LINCOLN PARK PLANNING COMMISSION

March 10, 2021 at 7 p.m.

Site Plan Review

Applicant	Clearwave Management, LLC
Project	Car Wash
Address	3727 Dix Hwy. Lincoln Park, MI 48146
Date	March 10, 2021
Request	Conceptual Site Plan Review
Recommendation	None - Advisory Only

PRELIMINARY CONCEPT PLAN

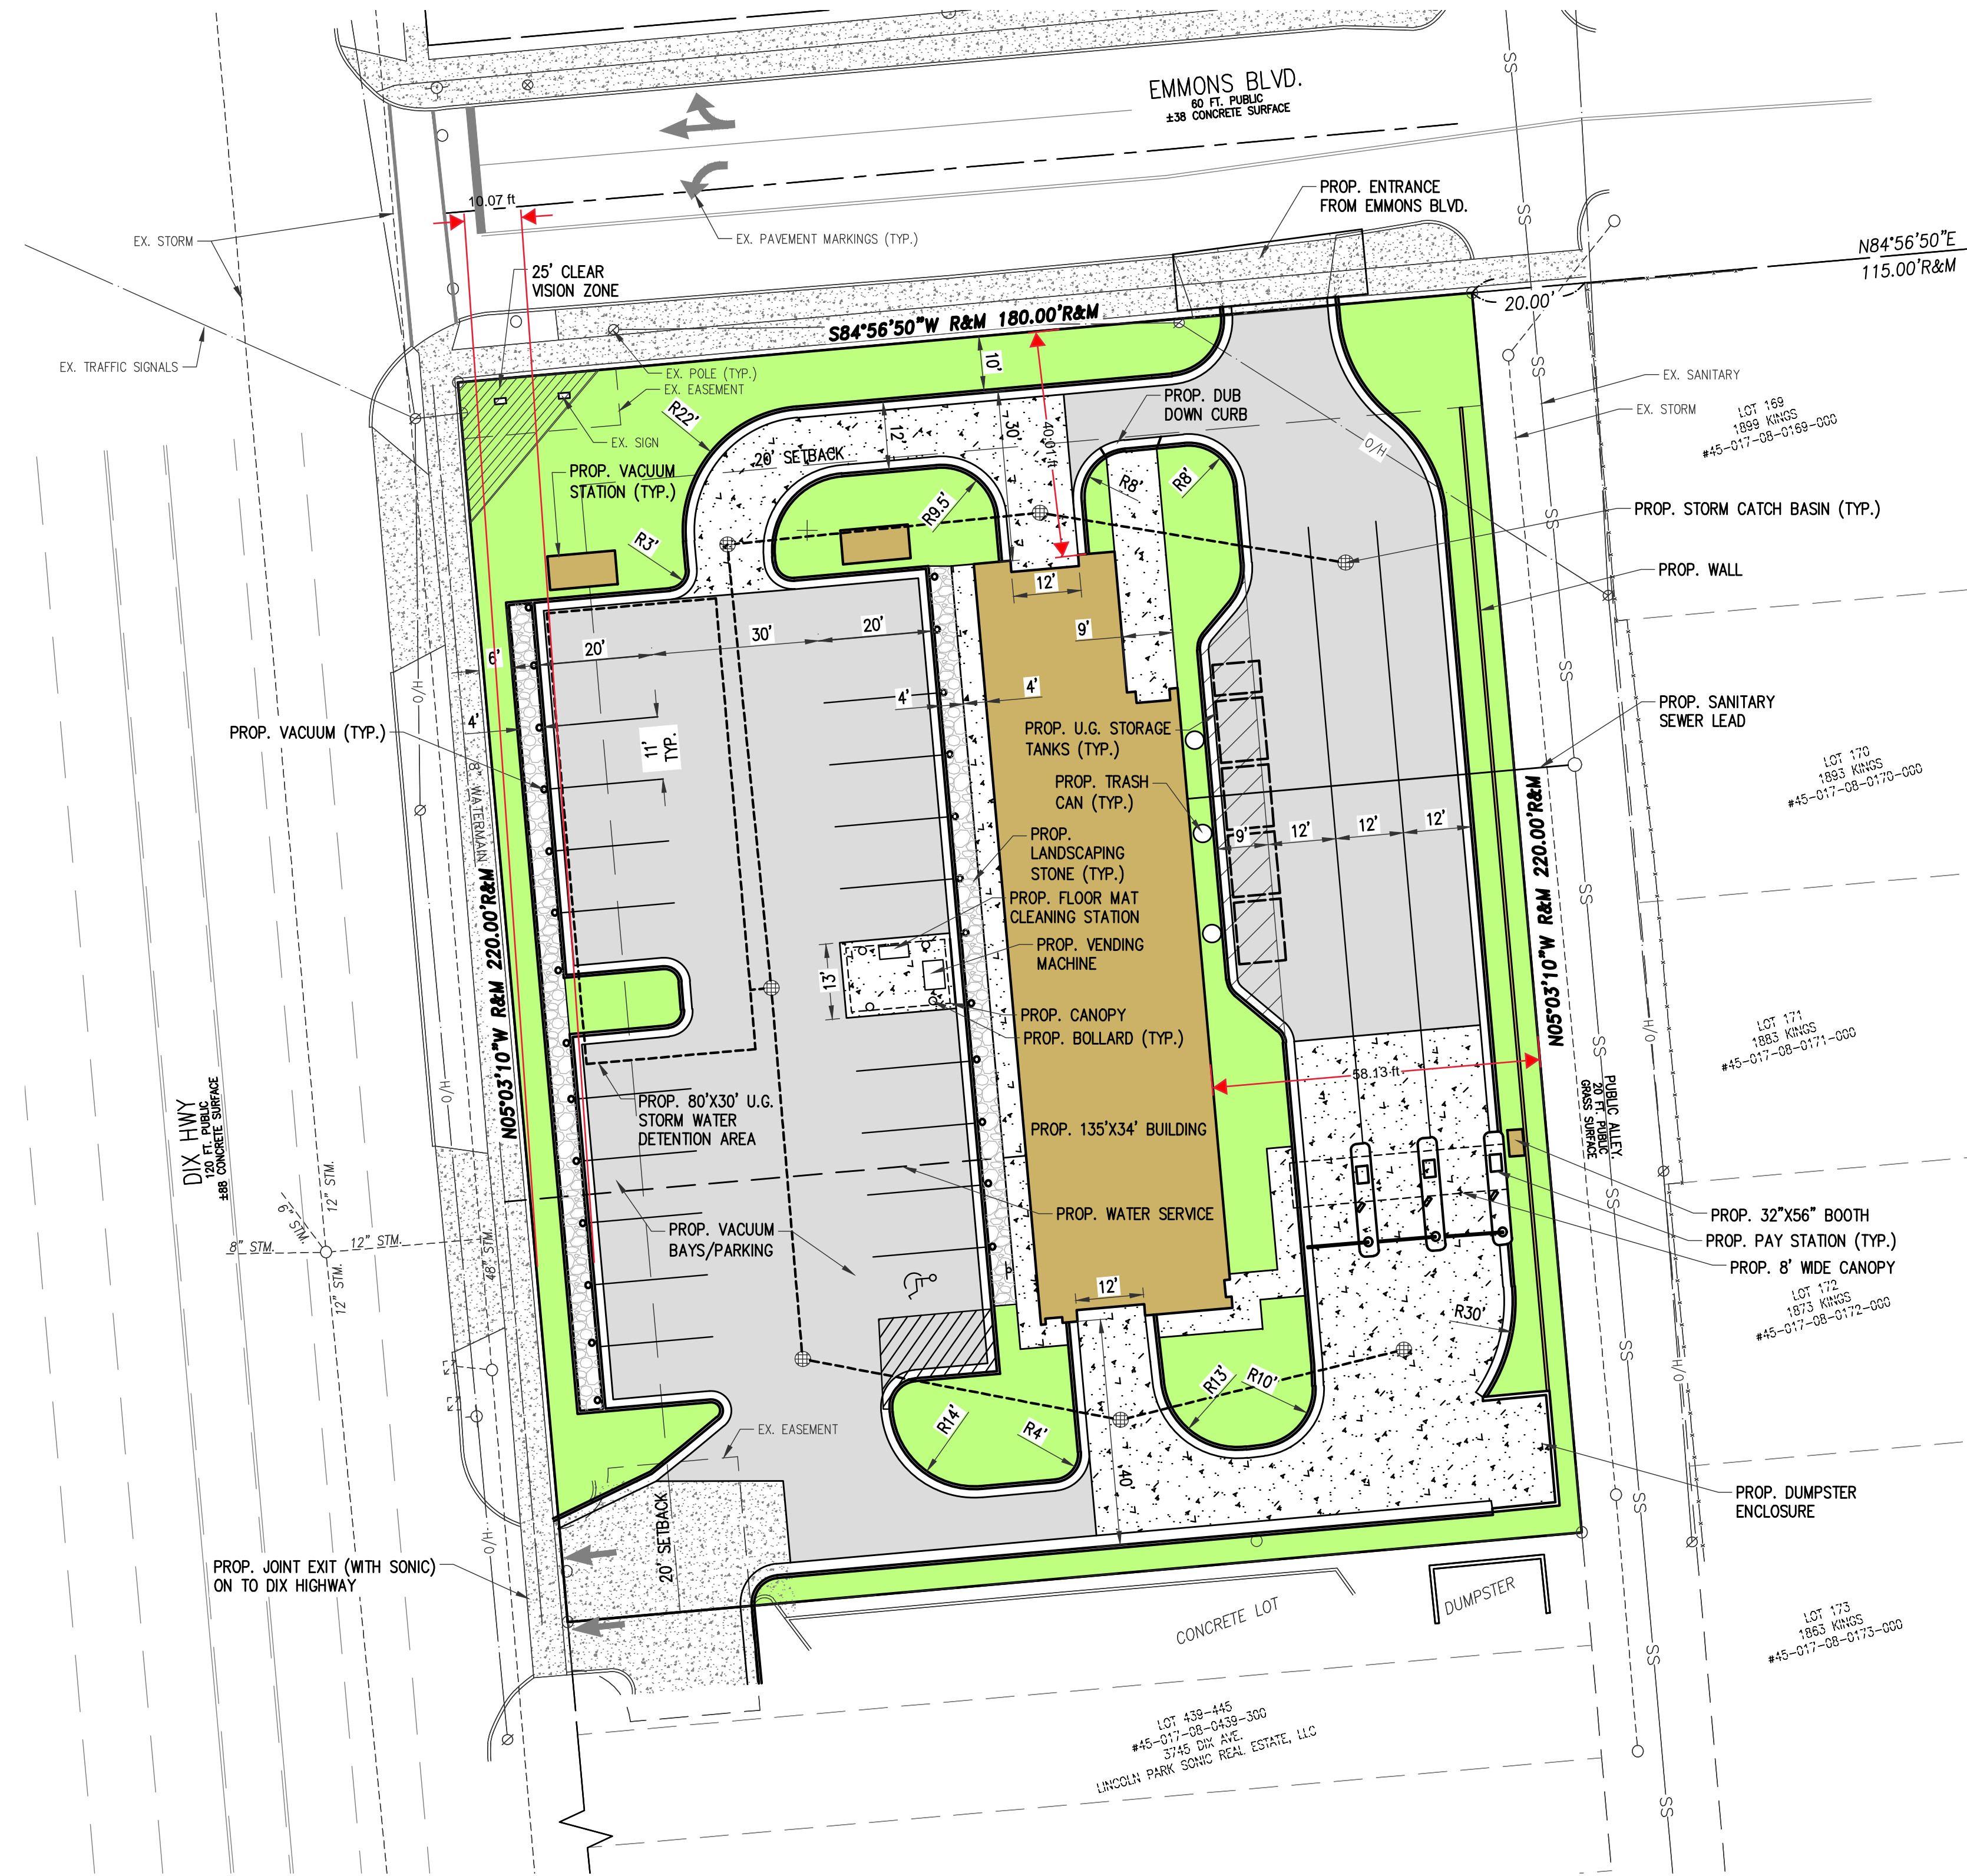
- Applicant shall show the required 16 stacking spaces with dimensions on the plan.
- Staff has raised concerns that the ingress on Emmons, although it meets the technical standard, may cause interference with the driveway on the south side of Emmons and at the light. Applicant comment requested.
- Applicant shall provide curb and gutter details per the City's standards.
- Applicant shall provide material, height, and construction details of the proposed screening wall.
- Applicant shall provide curb and/or post details for parking spaces abutting the public sidewalk along Dix Highway.

- Applicant shall provide drive radii on plan.

- Applicant shall provide the shared access agreement for the egress drive.
- Applicant shall provide a landscaping plan that supports the identified triangular unobstructed view area.
- Applicant shall provide details and comment on the shared access point and how it will function.
- Applicant shall evaluate alternate circulation patterns that would meet driveway alignment standards.

- Applicant shall provide a landscaping plan that meets the street, interior, and parking lot landscaping requirements of the Ordinance.
- Applicant shall provide dumpster enclosure details.
- Applicant shall provide screening wall details.

- Applicant shall show the required 16 stacking spaces with dimensions on the plan.

SHEET TITLE
FLOOR PLAN AND ELEVATIONS

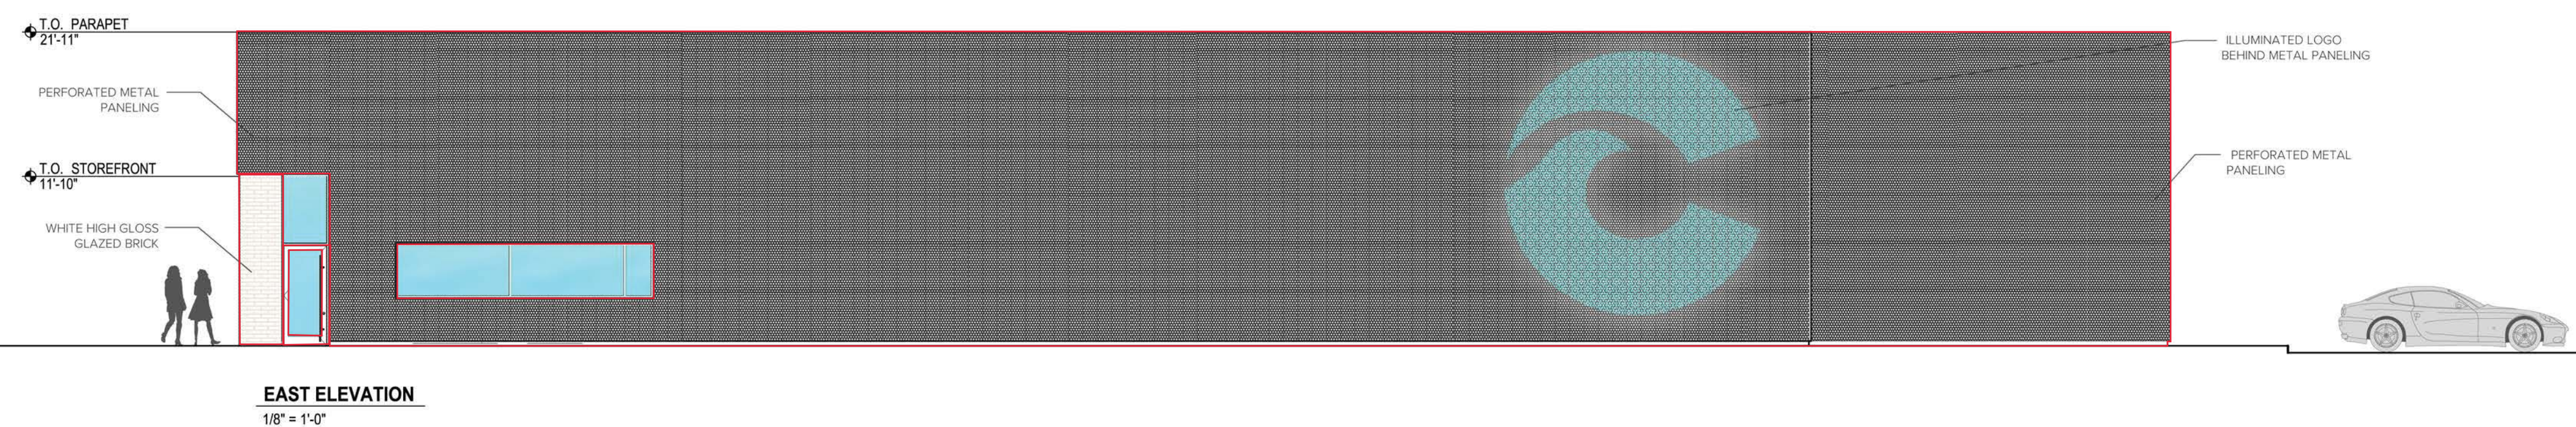
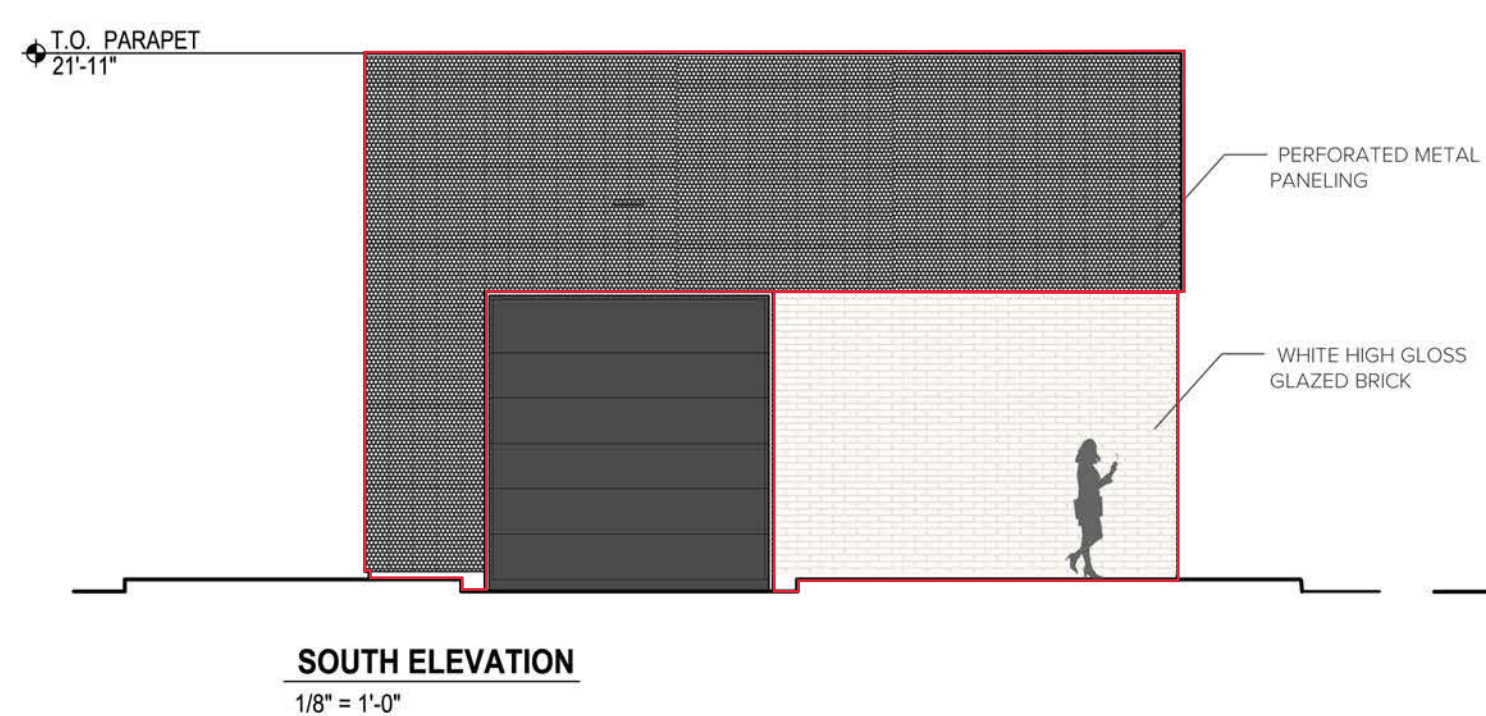
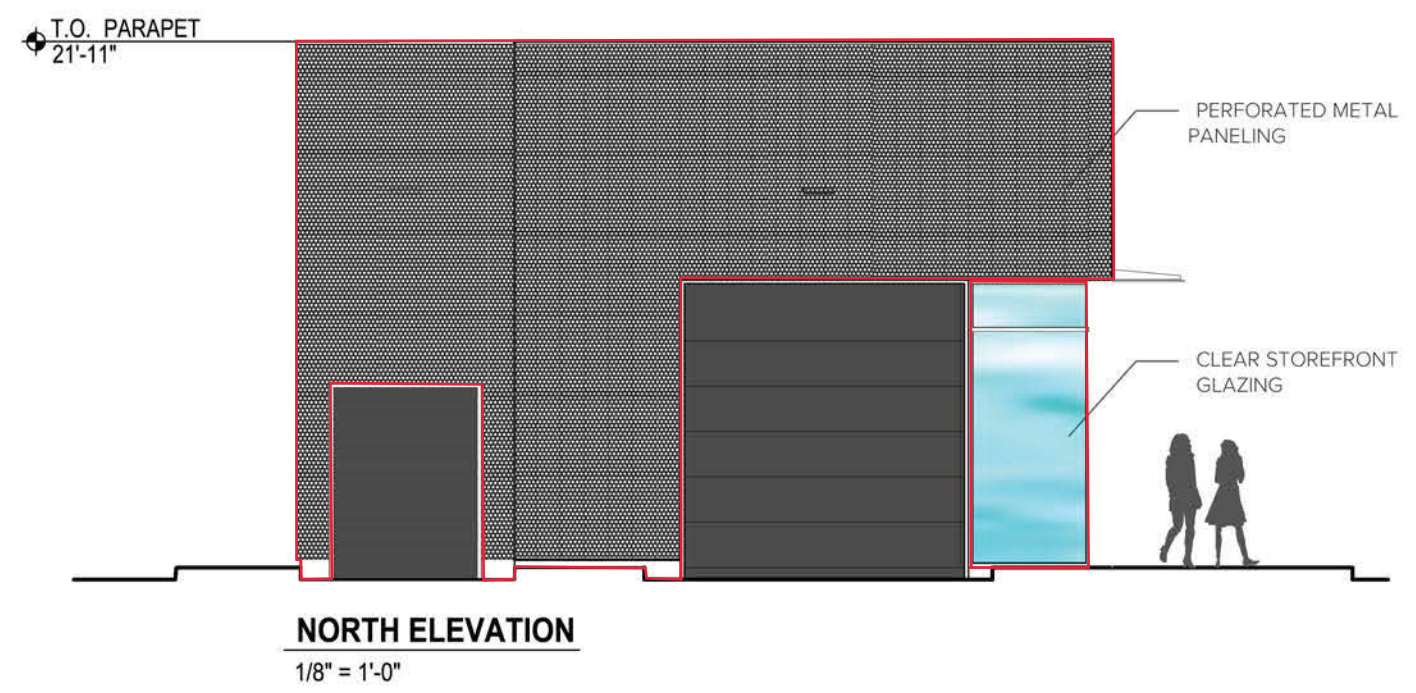
- Applicant shall revise façade materials to comply with façade material and transparency percentage requirements.
- Applicant shall show roof-top mechanical equipment screening, if applicable.

Site Plan - Proposed
Scale: 1/8" = 1'-0"

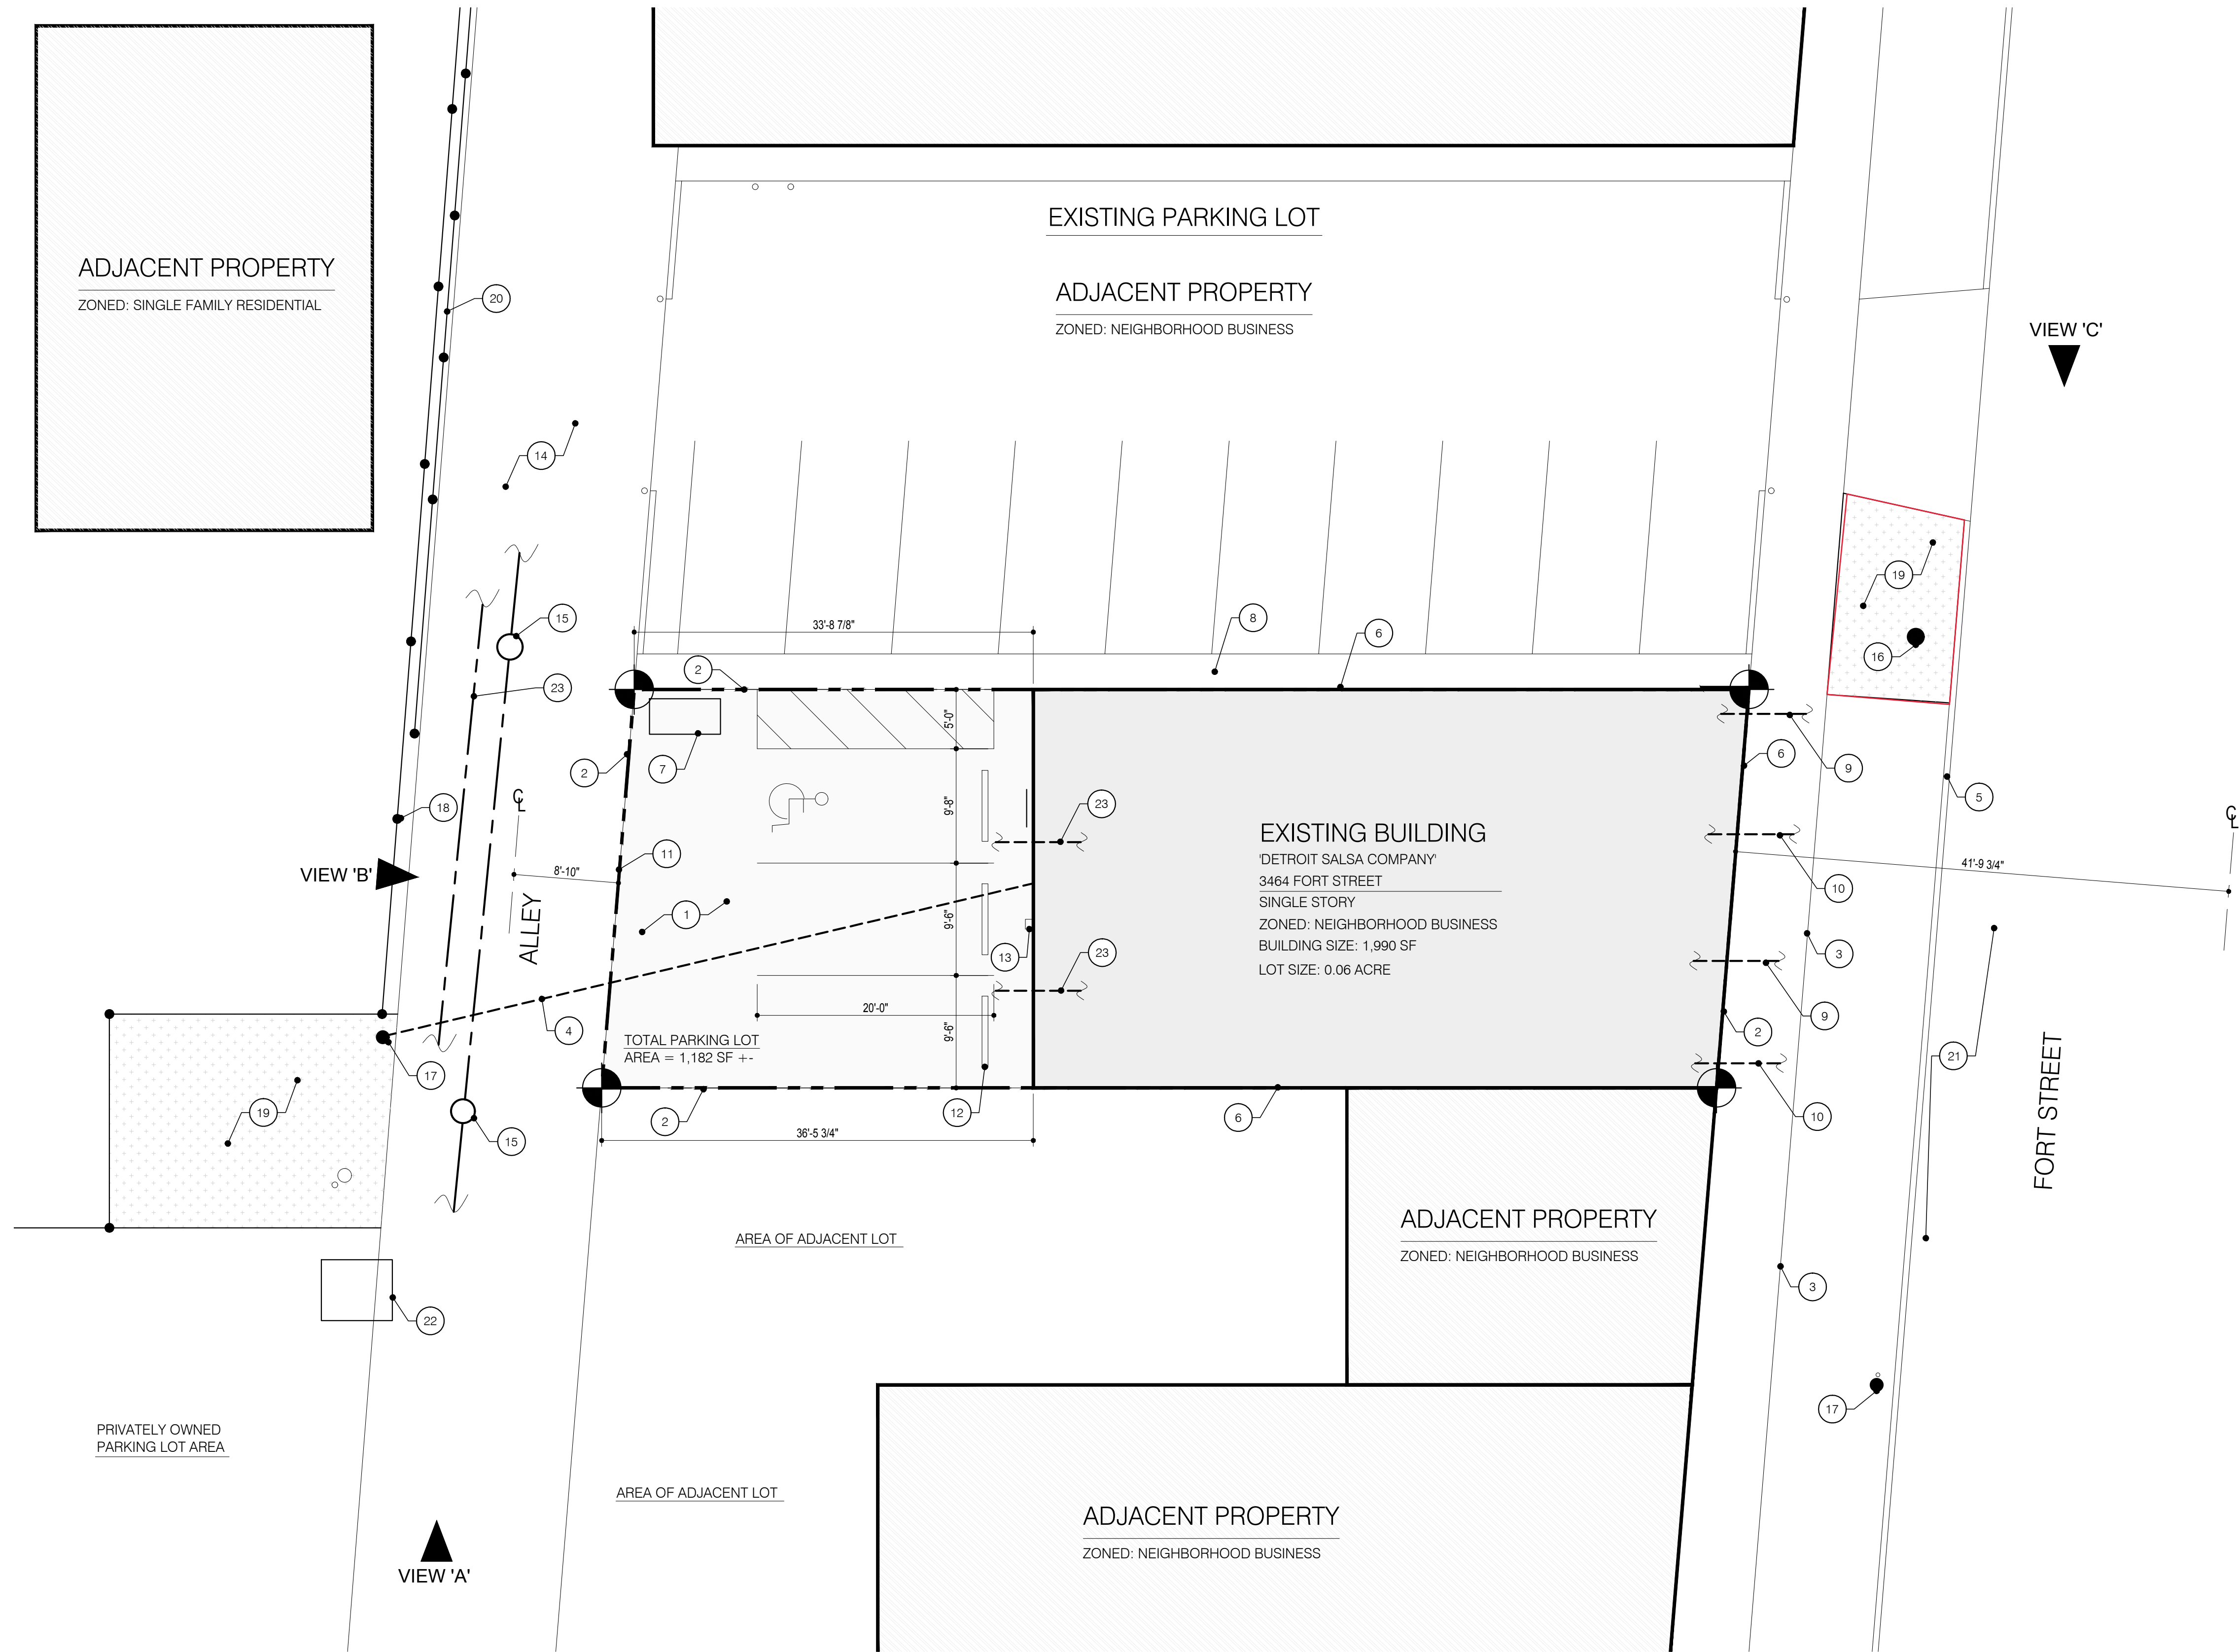
- The applicant shall request a Planning Commission waiver for the proposed parking plan of 3 spaces plus on-street parking along Fort Street.*
- The existing asphalt parking area shall be resurfaced and brought up to the City’s standards.*
- The cross section and pavement type for the parking lot shall be indicated on the plans and submitted to the Engineering Department for approval.*

- Applicant shall request a Planning Commission waiver from the landscaping and abutting residential screening requirements as the site is too small to accommodate such requirements.
- Applicant shall show waste receptacle screening meeting ordinance requirements, including installation detail.
